MILITARY SPECIFICATION

PROJECTILE, GUIDED, 155MM, XM712
THERMAL BATTERY FOR

This amendment forms a part of Military Specification MIL-P-63235 (AR), dated 31 August 1979, and is approved for use by the US Army Armament, Munitions and Chemical Command and is available for use by all Departments and Agencies of the Department of Defense.

Figure 1. +11 volt power source voltage and load profiles (0 to 100 seconds)

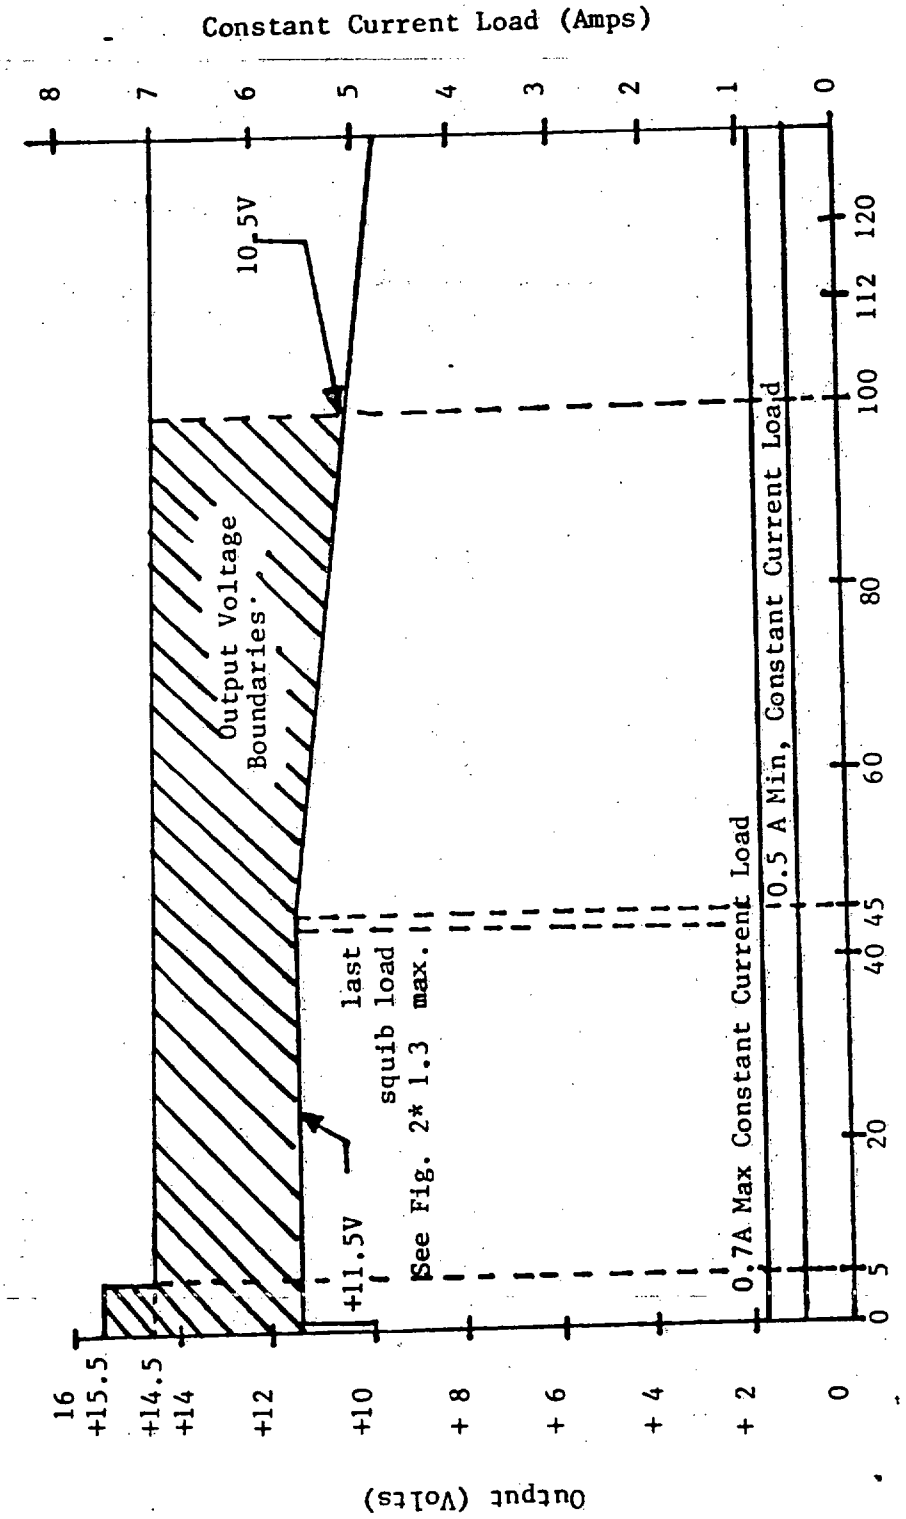
Delete Figure 1 entirely and substitute the included Figure 1.

* Refer to paragraph 3.2.1.1.1 for times at which squib loads can occur, minimum voltage permissible during squib loads, and recovery time.

Figure 2. +11V power source voltage and load profiles (0 to 1.5 seconds)

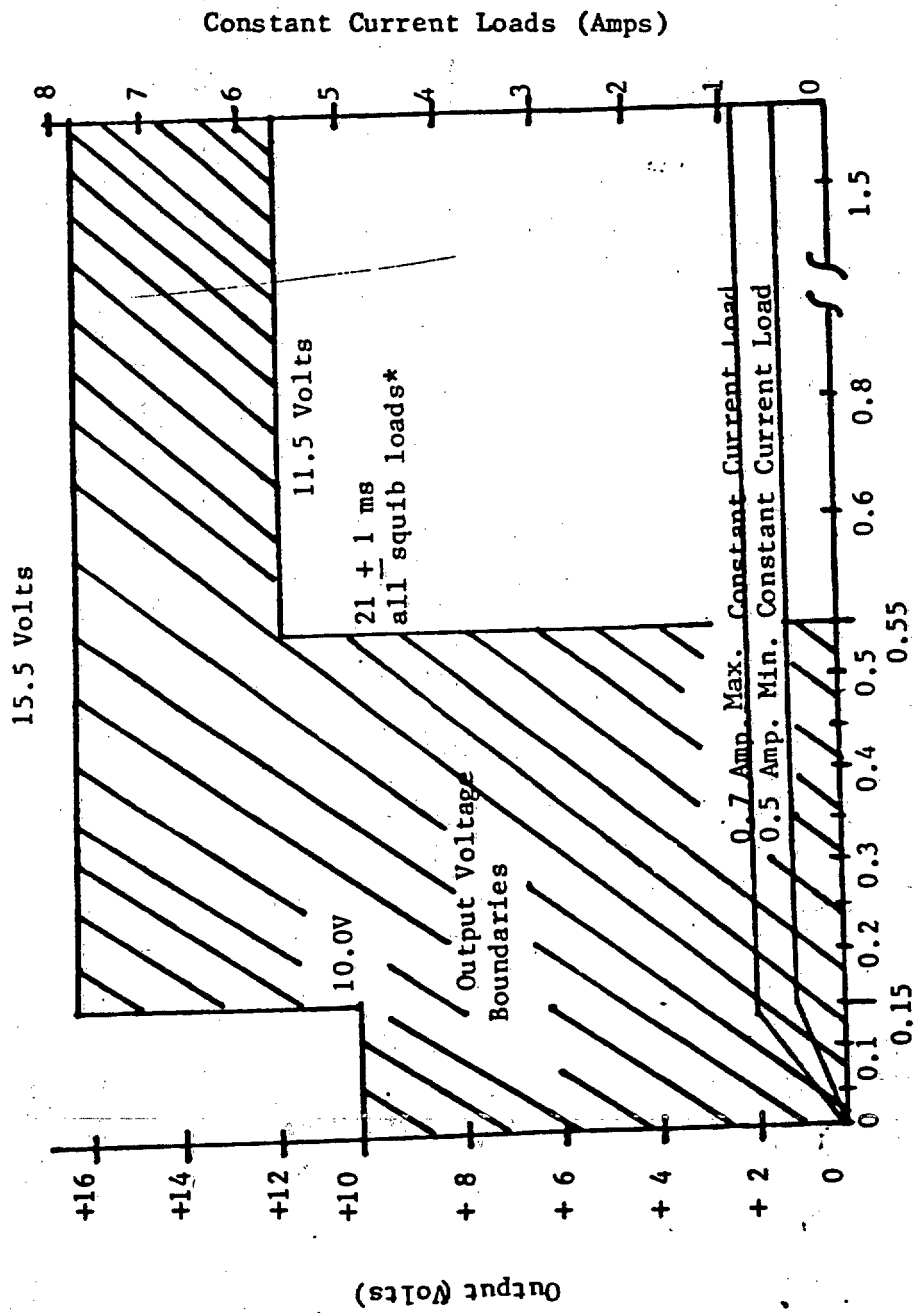
* Delete Figure 2 entirely and substitute the included Figure 2.

* Refer to paragraph 3.2.1.1.1.1.1 for times at which squib loads can occur, minimum voltage permissible during squib loads, and recovery time.

Figure 3. +30 volt power source voltage and load profiles (0 to 70 seconds)

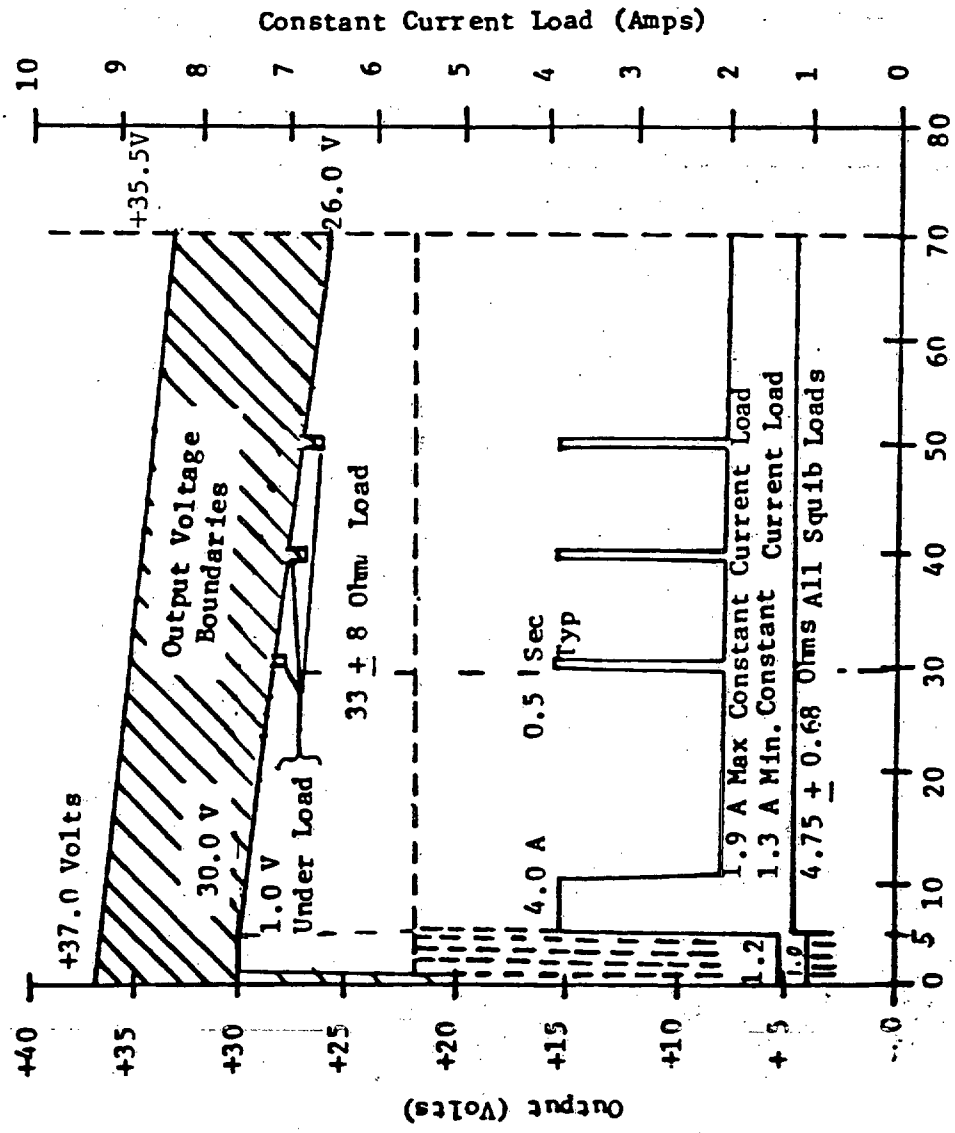
* Delete Figure 3 entirely and substitute the included Figure 3.

Figure 4. +30 volt power source voltage and load profiles (0 to 5.5 seconds) (typical squib pattern shown)

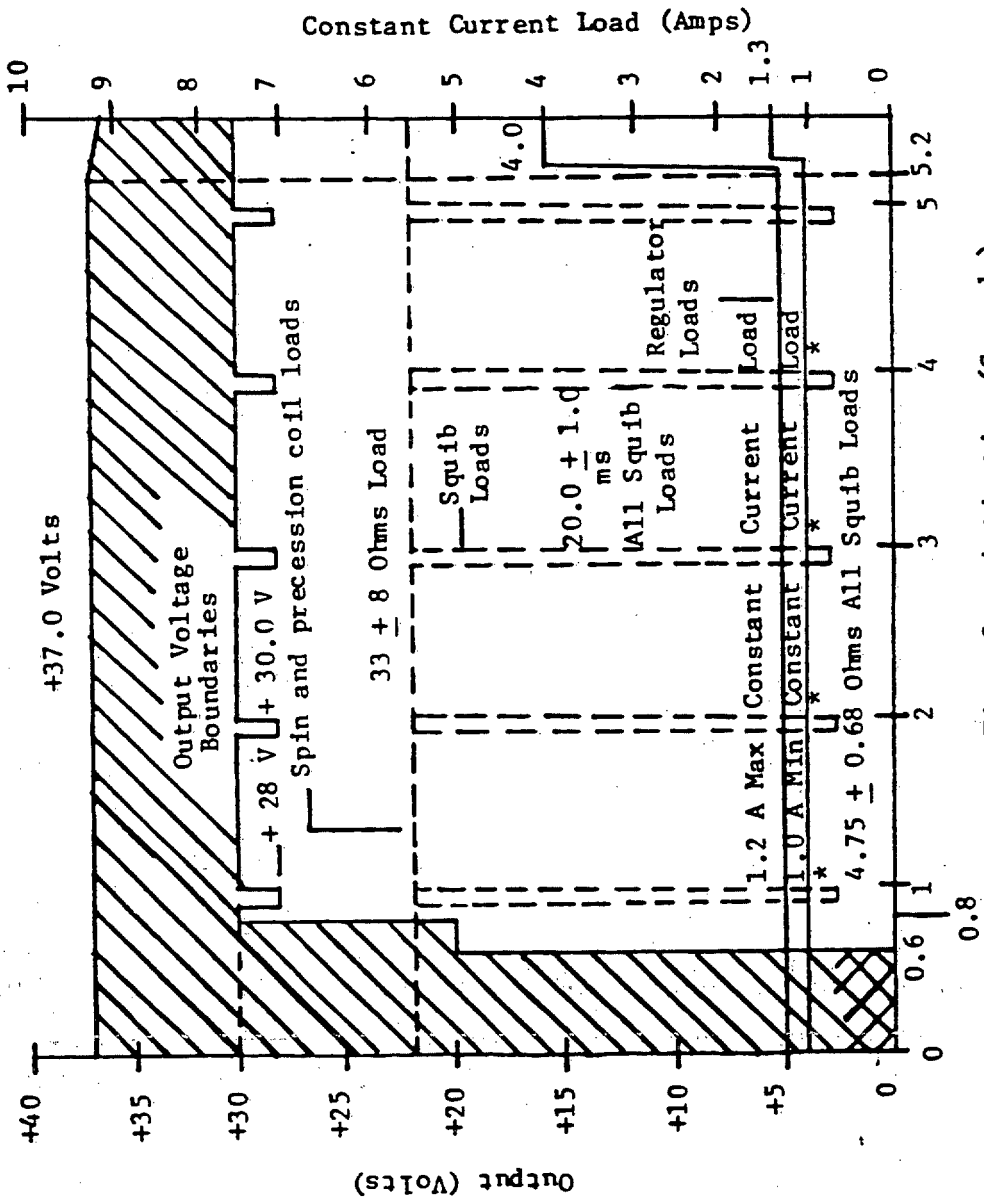
Delete Figure 4 entirely and substitute the included Figure 4.

* Refer to paragraph 3.2.1.1.2.1 for times at which squib loads can occur, minimum voltage permissible during squib loads and recovery time.

Figure 5. -30 volt power source voltage and load profiles (0 to 70 seconds)

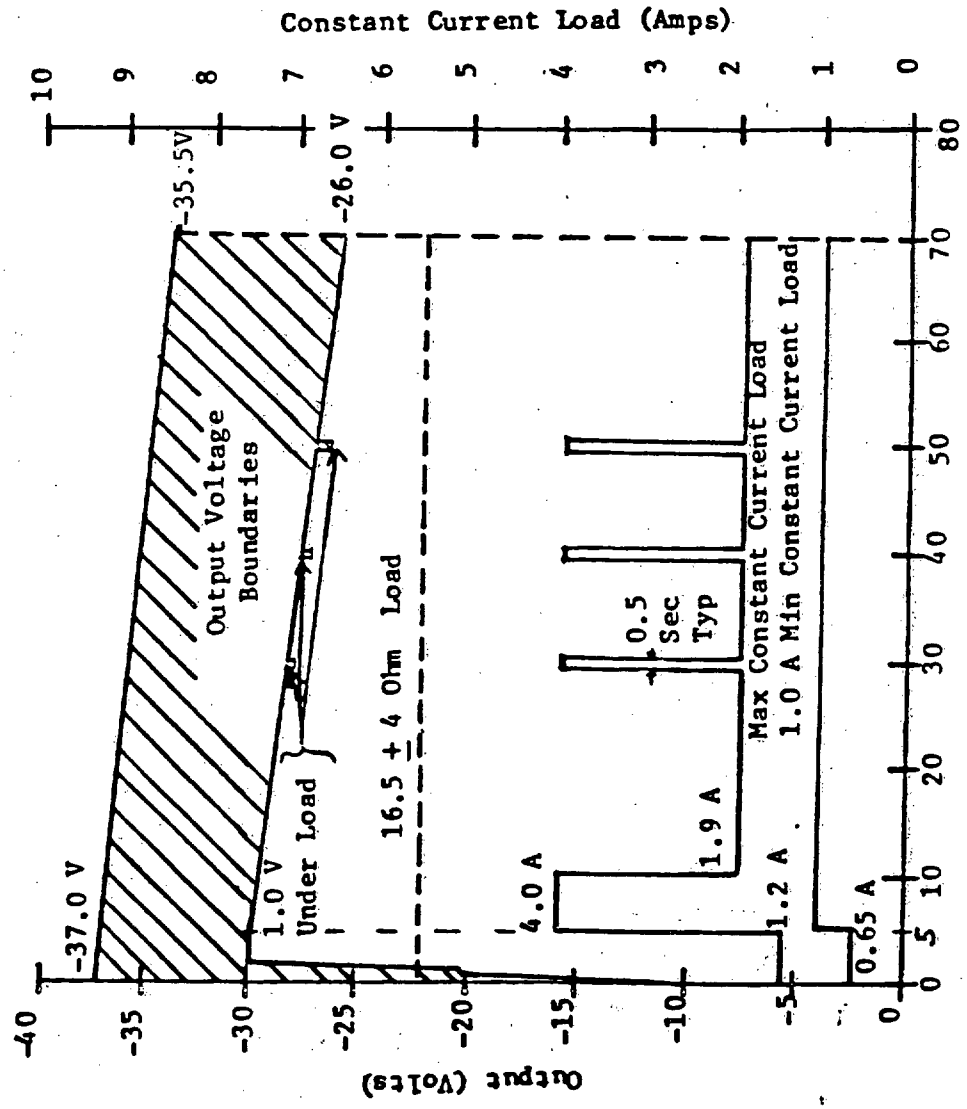
* Delete Figure 5 entirely and substitute the included Figure 5.

Figure 6. -30 volt power source voltage and load profiles (0 to 70 seconds)

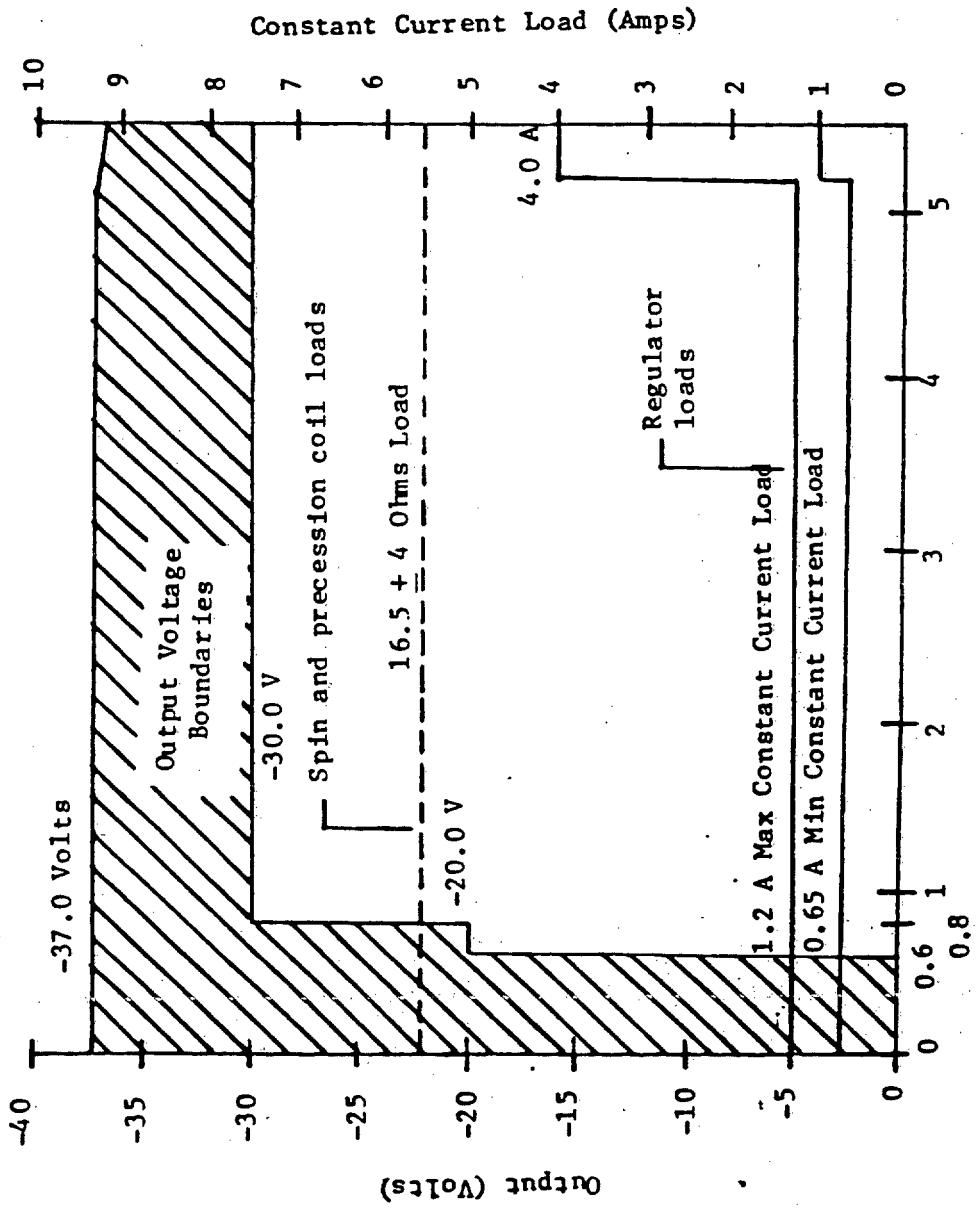
Delete Figure 6 entirely and substitute the included Figure 6.

Figure 7. output voltage rise time boundaries for +11 volt source

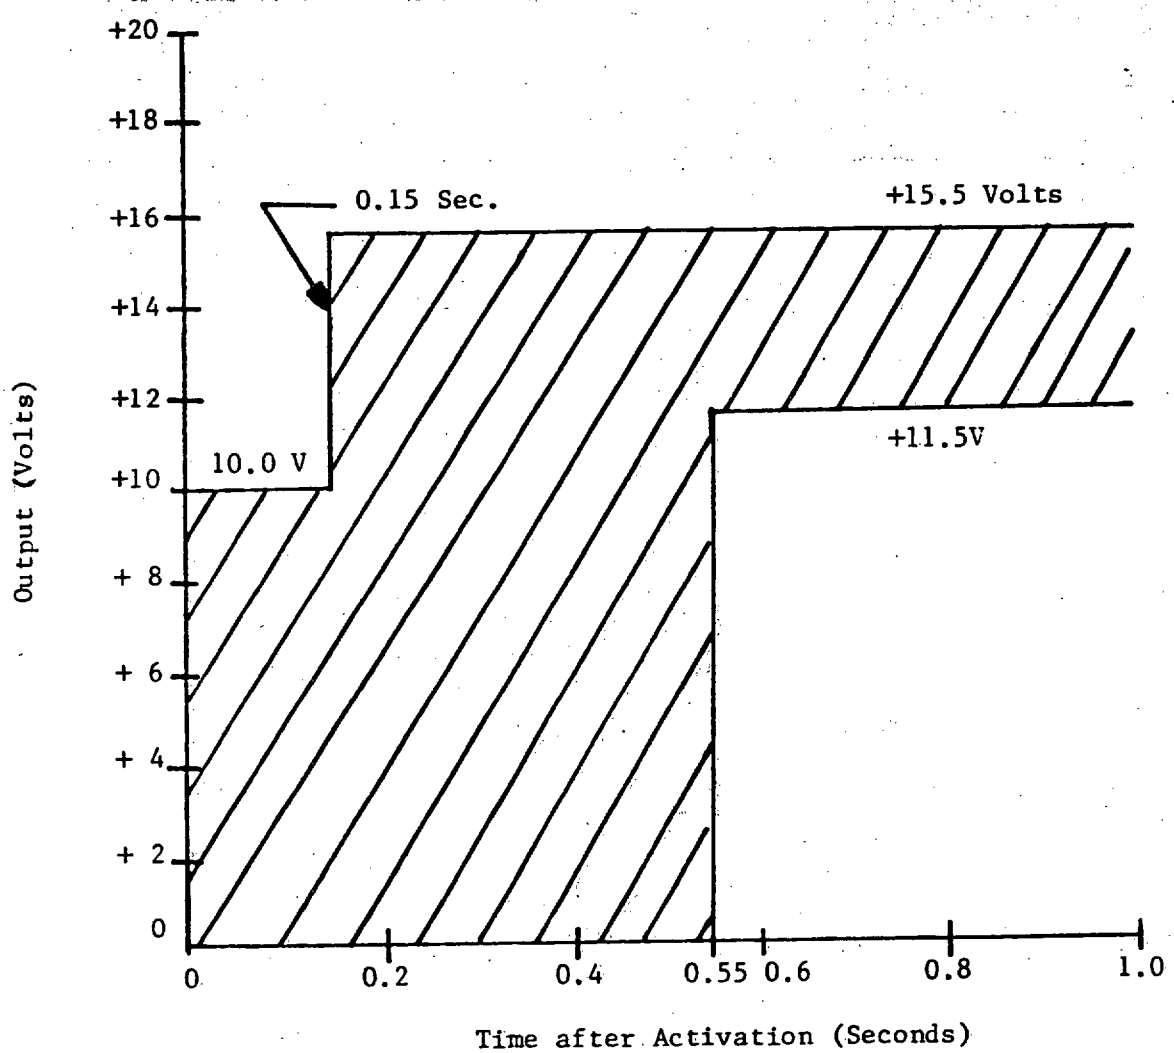
Delete Figure 7 entirely and substitute the included Figure 7.

NOTE: Refer to paragraph 3.2.1.1.1.1 for times at which squib loads can occur, minimum voltage permissible during squib loads, and recovery time.
